# SP202400025 400 Rio Rd. W Outdoor Storage, Display, and Sales

# SP202400025 Factor Favorable and Recommendation

Albemarle County Board of Supervisors  
Public Hearing  
May 21, 2025

# Conceptual Plan

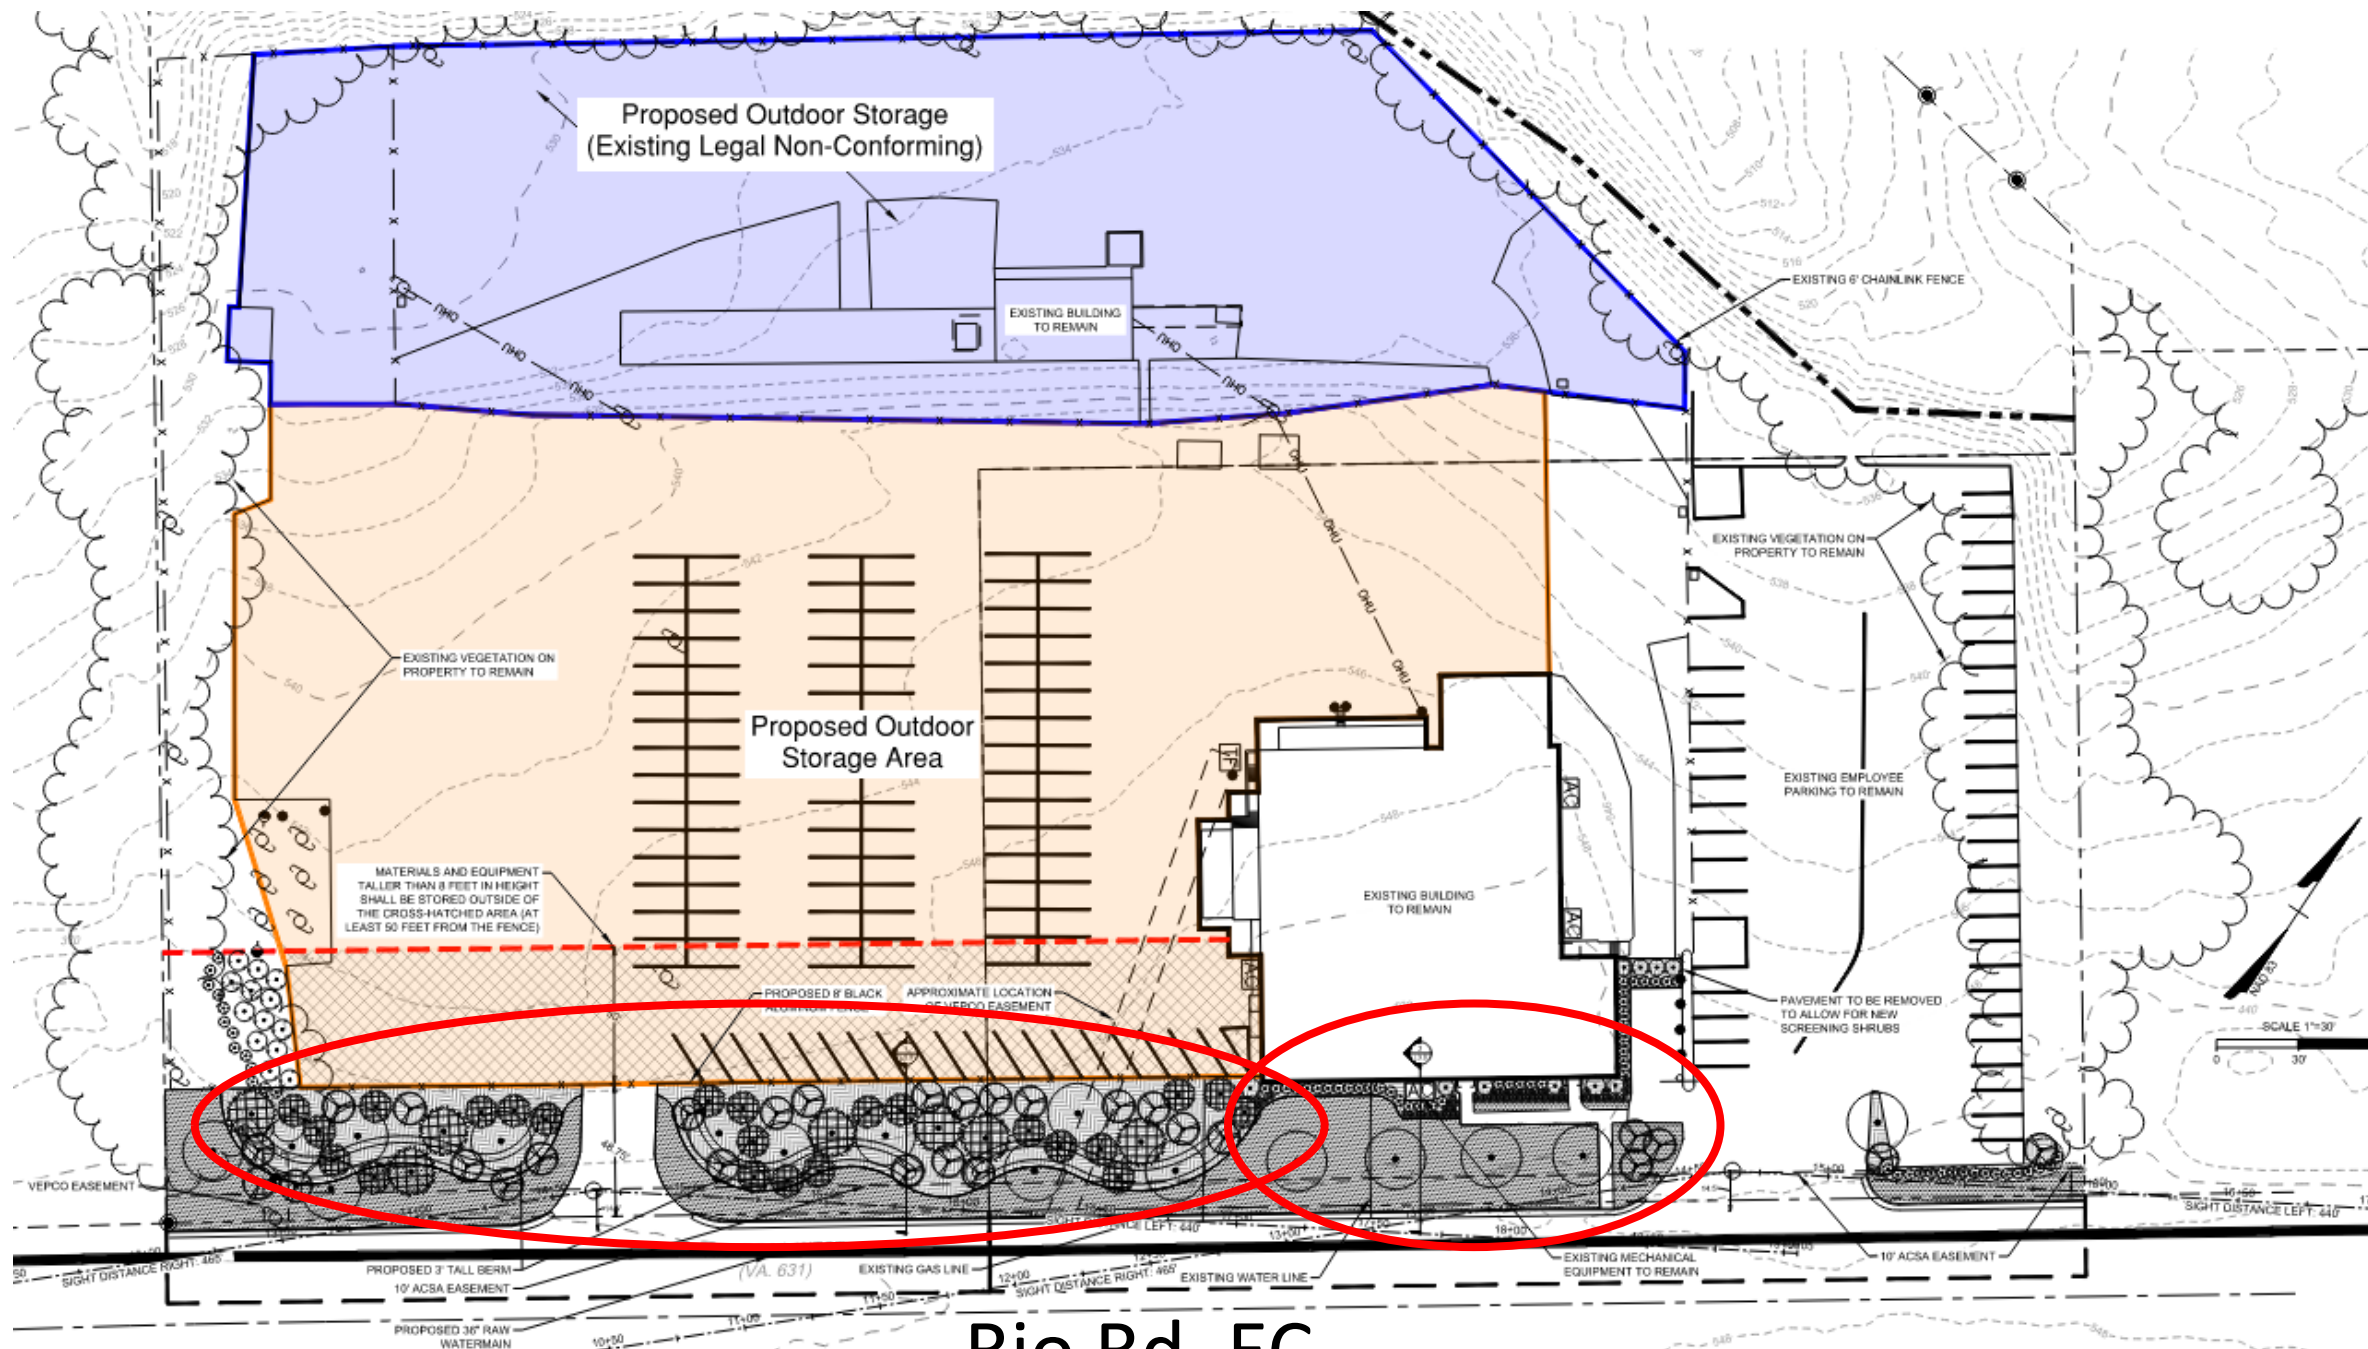
1. Use of this site must be in general accord with the 400 Rio Rd. W Conceptual Layout Plan by Timmons Group dated March 07, 2025. To be in general accord:

- a) Materials and equipment must be stored only in areas indicated for storage on the Concept Plan; and
  - b) The security fence must be a metal picket style and is subject to ARB approval with the final site plan.

2. Materials and equipment taller than the fence height must be stored outside of the cross-hatched area as shown on the Concept Plan.
3. Site plan approval is subject to ARB approval of the landscape plan (submitted with the site plan). Landscaping shown on the plan may be required to exceed the minimum requirements of the ARB guidelines and/or the Zoning Ordinance to mitigate the visual impacts of the proposed use.
